SERVICE CAMPAIGN

Air Bag Control Unit (ACU) Liquid Intrusion
Voluntary Service Campaign

Reference: PM674
Date: March 15, 2017

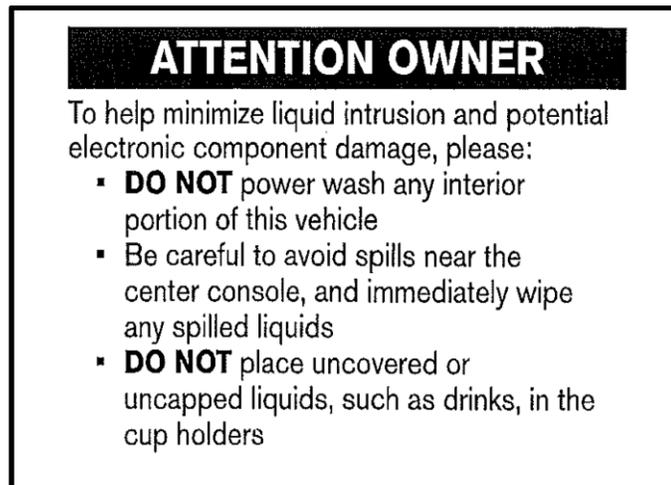
The Air bag Control Unit (ACU) is located under the center console. Liquids spilled on or around the center console area or power washing the floor may contact ACU connections at the ACU circuit board.

- A. Liquid intrusion may lead to corrosion of the Air bag Control Unit (ACU), which may result in illumination of the air bag warning lamp and deactivation of front air bags.

Dealers will **now** verify the air bag warning lamp is operating correctly and install foam to the center console. If the air bag warning light is not operating correctly, dealers will replace the Air bag Control Unit (ACU) in addition to installing the foam on the center console. Nissan expects a very small amount (< 1%) of vehicles to require ACU replacement.
